2006 - 2009 Cadillac XLR XLR-V: Service Bulletin: Slips in Reverse or Third, Delayed Reverse or Drive Engagement

#09-07-30-004J: Slips in Reverse or Third, Delayed Reverse or Drive Engagement, DTC P0776, P2715, P2723, Harsh 2-3 Shifts (Inspect 1-2-3-4 / 3-5-R Housing and Pump Seal Rings) - (Feb 25, 2014)

This bulletin has been revised to update the 2006 - 2009 Vehicles correction

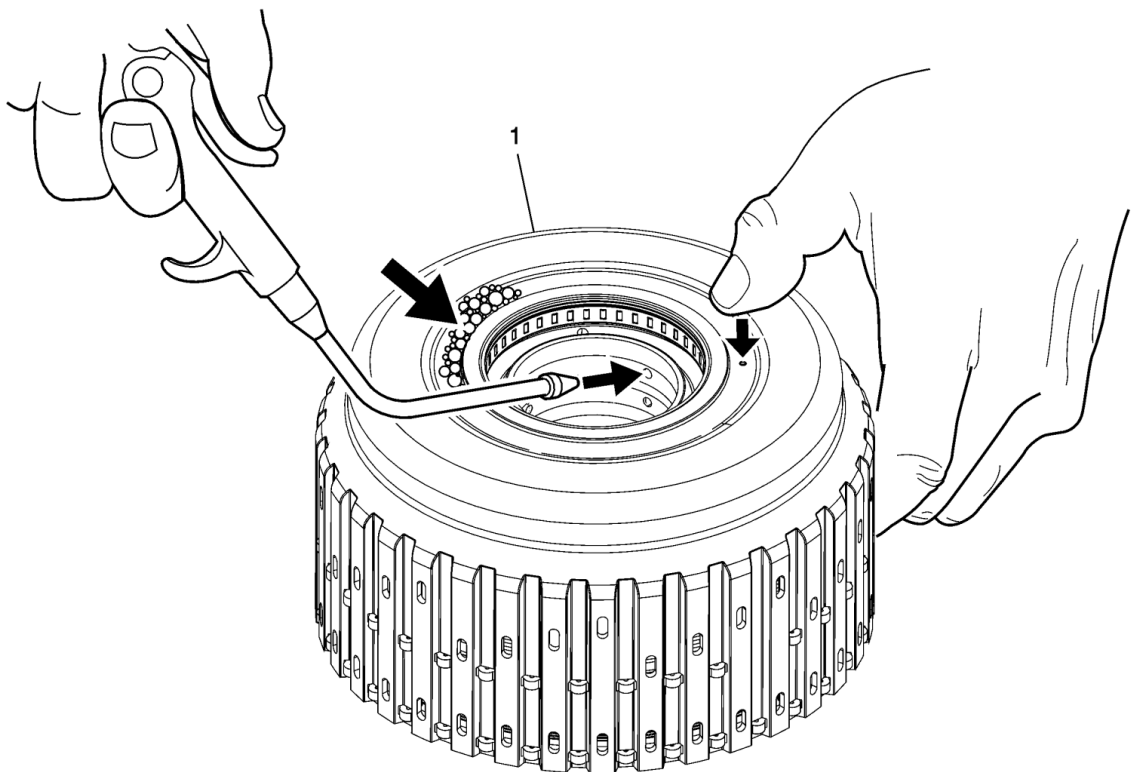
This condition may be caused by a cracked 1-2-3-4 / 3-5-R clutch housing.

Important: If a cracked housing is identified, it must be replaced. Complete, assembled 1-2-3-4 / 3-5-R clutch housings are now available for most applications. These clutch housings come complete with all pistons, seals, clutches, bearing and internal parts. No assembly of the clutch housing is required before it is installed. For applications without a complete, assembled 1-2-3-4 / 3-5-R clutch housing, individual parts must be ordered and the housing assembled in the

Housing Disassembled

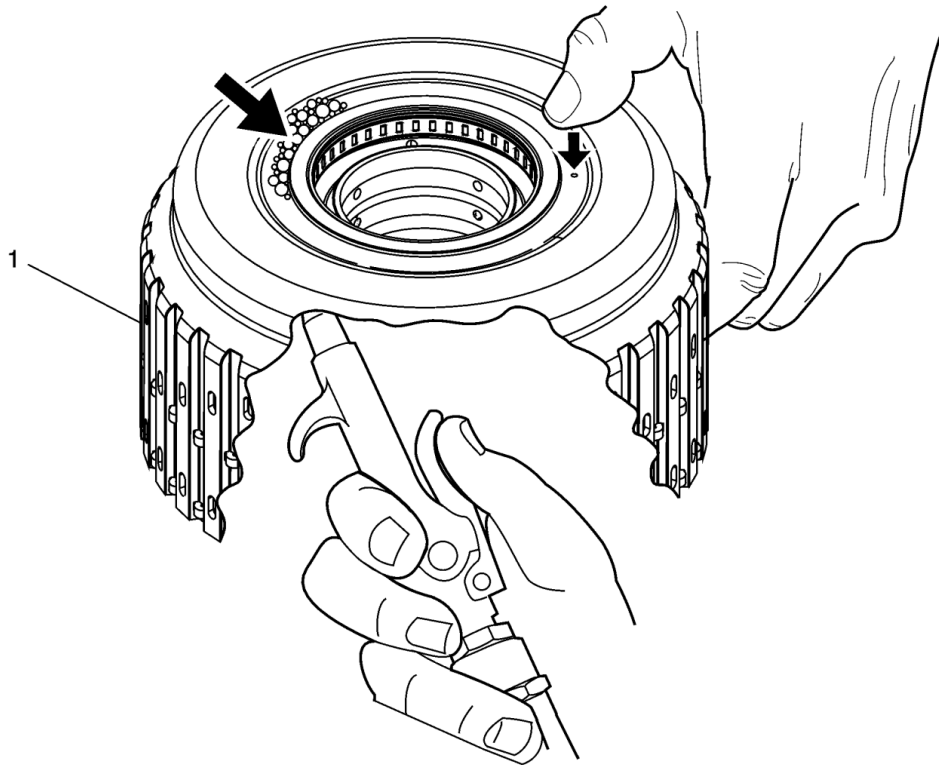
Inspect the 1-2-3-4 / 3-5-R clutch housing for a possible cracked weld.

1. Apply soap compound to weld area of the housing.
2. Hold your thumb over the air bleed passage.
3. Spray compressed air into the housing and inspect the weld area for bubbles.
4. If bubbles are detected, a new housing is required.

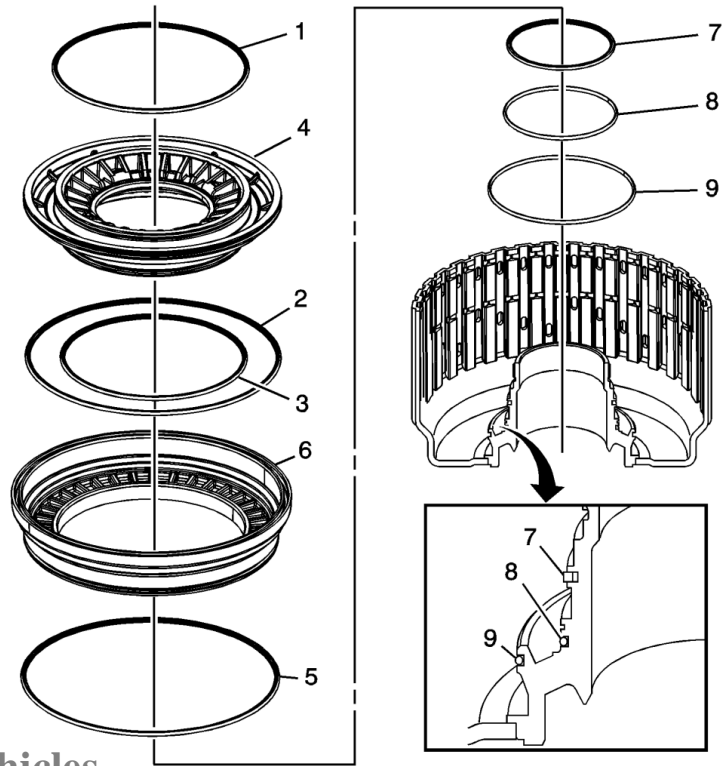
Important: The 6L80 transmission had a design change to the 1-2-3-4 piston, 1-2-3-4 piston housing and the 3-5-R piston for the 2008 model year. Installation of a 2008, 6L80 complete housing assembly into a 2007 or older 6L80 may result in a 2-3 shift flare or 3-5-R clutch distress.

Important: When installing a new 1-2-3-4 / 3-5-R housing into a 2007 or older 6L80, be sure to install all three (3) inner seals (7, 8, 9 in illustration below). Failure to install these seals can result in no reverse, no forward or distressed clutches.

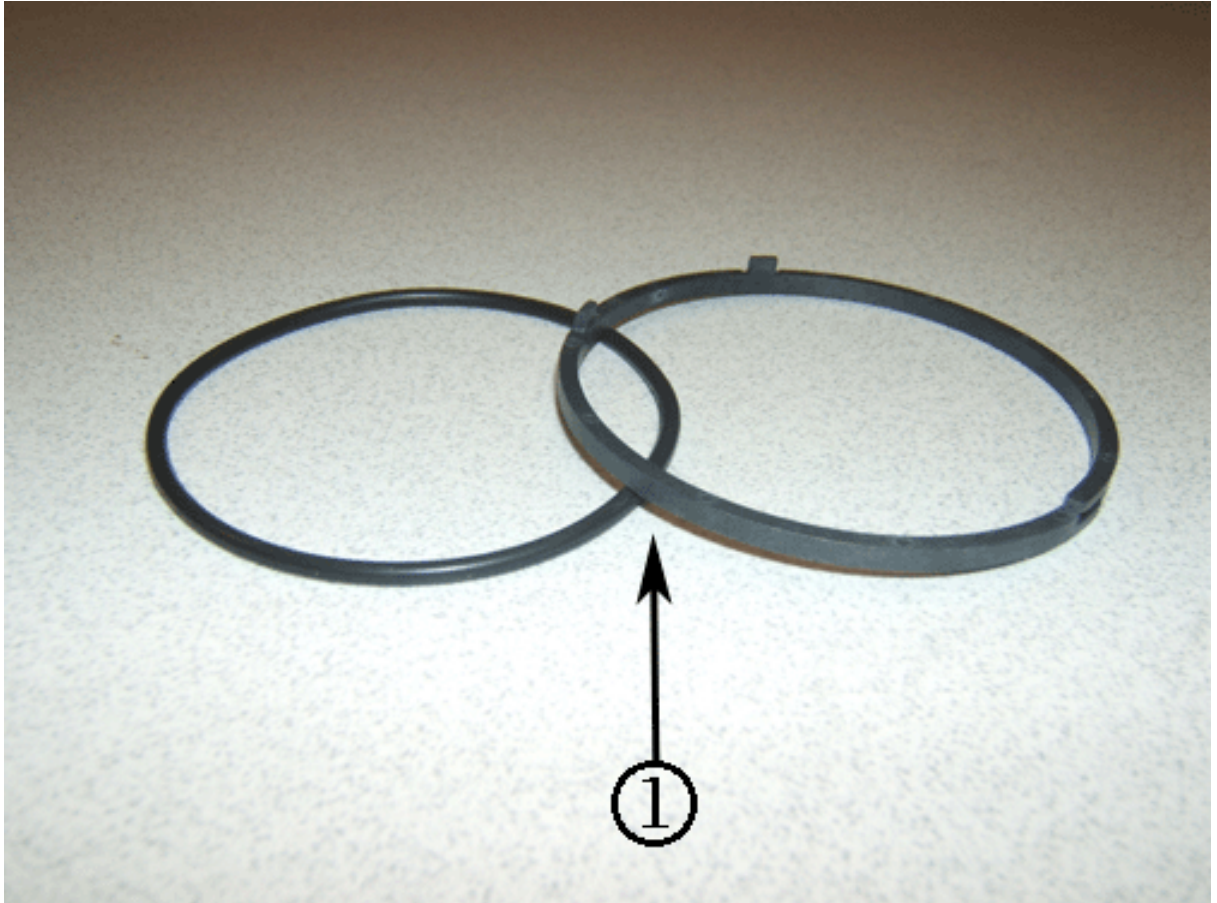
A harsh 2-3 shift condition may be caused by leaking 1-2-3-4 and 3-5-R clutch fluid seal rings (1) on the transmission fluid pump cover assembly.

Inspect the fluid seal rings. Transmissions in 2006, 2007, 2008 and early build 2009 models used a 1- piece design seal ring in production. Starting December 2008, a 2-piece seal ring design was implemented. The 1-piece seal ring design may cause a harsh 2-3 shift due to leakage. This is typically a low mileage issue. If the seal rings are a 1-piece design they should be replaced with new 1-piece design seal rings. It is not necessary to replace the pump cover.

Notice: The clutch fluid seal rings must be installed in a specific way. Failure to install new clutch fluid seal rings in the proper orientation may cause a repeat harsh 2-3 shift. Refer to 1-2-3-4 and 3-5 Reverse Clutch Fluid Seal Ring Installation (6L80/90) in SI for correct installation.

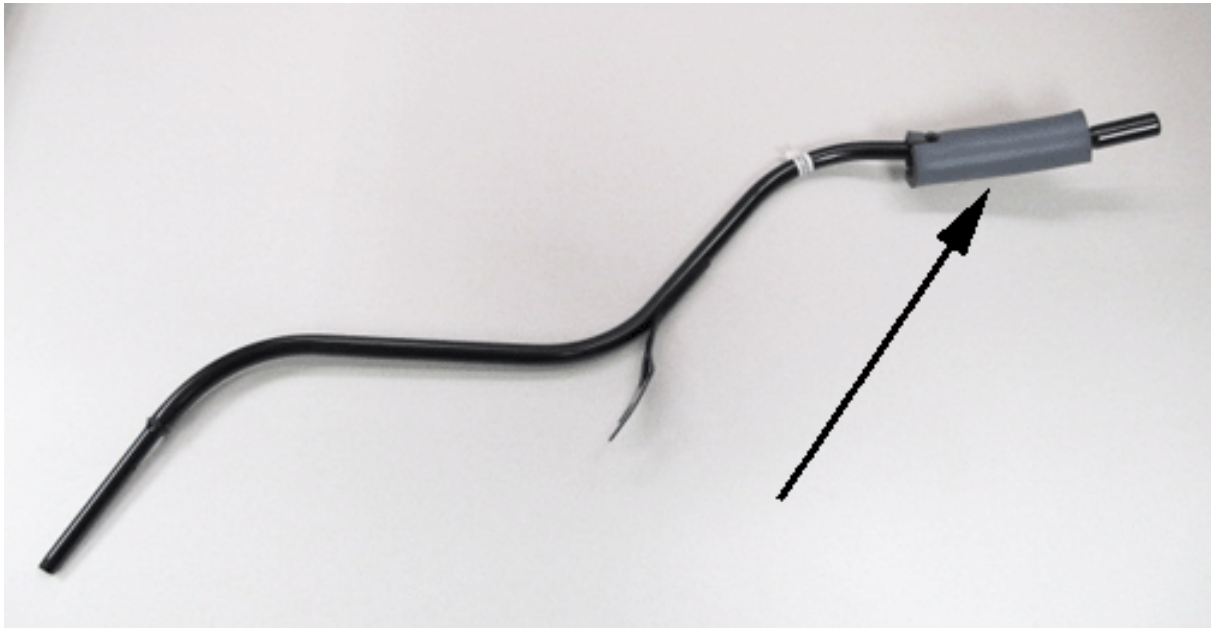
If the seals are the 2-piece design shown below, they do not need to be replaced unless they are worn or damaged.

Important: Do not install 1-piece design seal rings on a 2-piece seal

ring design pump cover. The 2-piece seal ring design pump cover can be identified by the notch in the seal ring grooves that accepts the tab on the 2-piece design seal rings.
